GEOCRES No. 31C-123

LOCATION X-ing of Mellon Creek
Relocated Hwy. 41 (Line B)

SUBJECT: *Preliminary Foundation Recommendations for
the Proposed New Structure at the Crossing
of Mellon Creek and Relocated Hwy. #41
W.O. 73-11055 -- W.P. 229-65*

FOUNDATION INVESTIGATION REPORT
For
The Proposed New Structure
at the Crossing of Mellon Creek
and Relocated Hwy. 41 (Line 'B')
Township of Sheffield
County of Lennox & Addington
District No. 8 (Kingston)
W.O. 73-11055 - W.P. 229-65

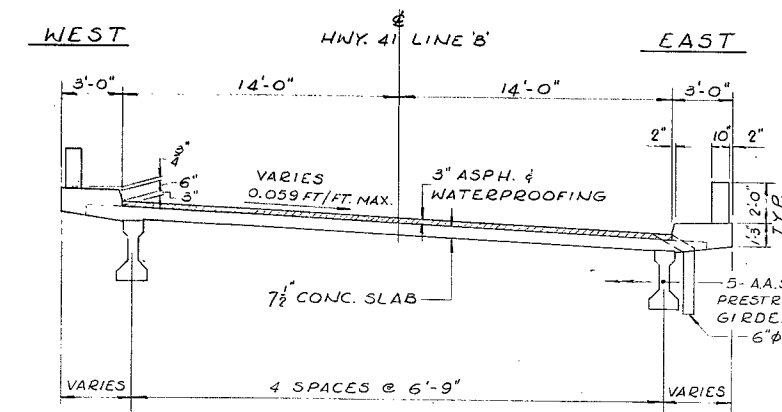
We have reviewed the Preliminary Bridge Drawing 17-224-P1 for the abovementioned structure and submit the following comments.

1. It was recommended in our Foundation Report that the footings be supported on end-bearing piles driven to bedrock. According to the preliminary Structural Drawing, spread footing type foundations are proposed, for the simply supported structure. The footings will be placed within the approach embankments consisting of rock fill at EL. 540, with a design load of 2.0 t.s.f. From the stability point of view, no major problems are anticipated.

2. All soft organic material within the plan limits of the embankments to be removed to its full depth and replaced with rock fill.
3. The underlying clayey silt subsoil will undergo settlements due to the weight of the superimposed embankment. It's estimated that the settlement which is recompressed in nature, will be in the order of 2.0 to 3.0 inches. To minimize the effect of the settlement on the structure it is recommended that the rock fill at the abutment locations be placed three months prior to the construction of abutments.

The submitted plan shows spread footing support. While our recommendations in the report or subsequent memo has been pile support.
